Clio II, Kangoo, Megane 1.4i E7J Engine

COTB 0007

MOUNTING BOLT VARIATIONS FWP1752 / FWP2149

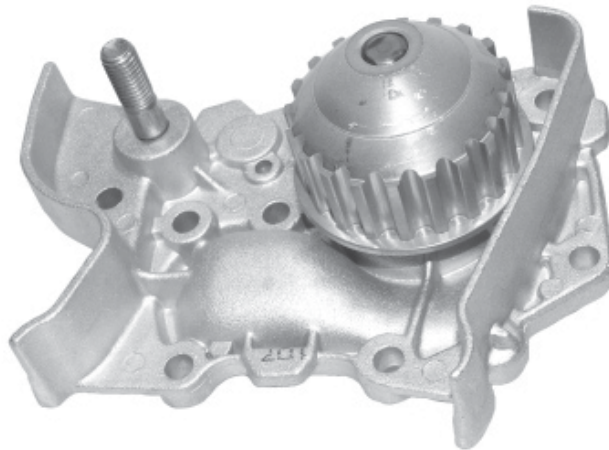
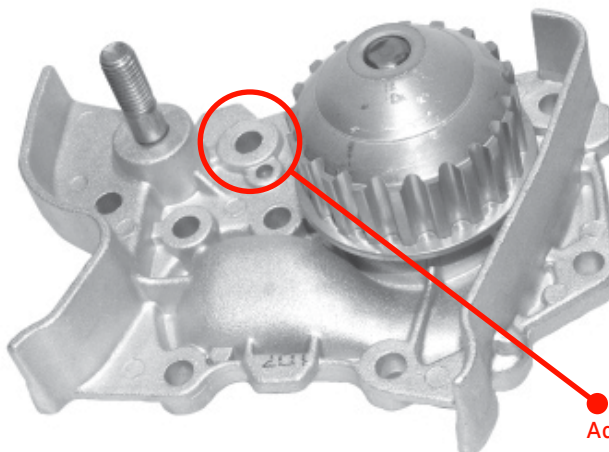
There are 2 designs of Water Pump available for the vehicles listed above. **FWP2149** incorporates an additional bolt hole into the casting. Please ensure you choose the correct Water Pump before replacement.

Additional Mounting Hole
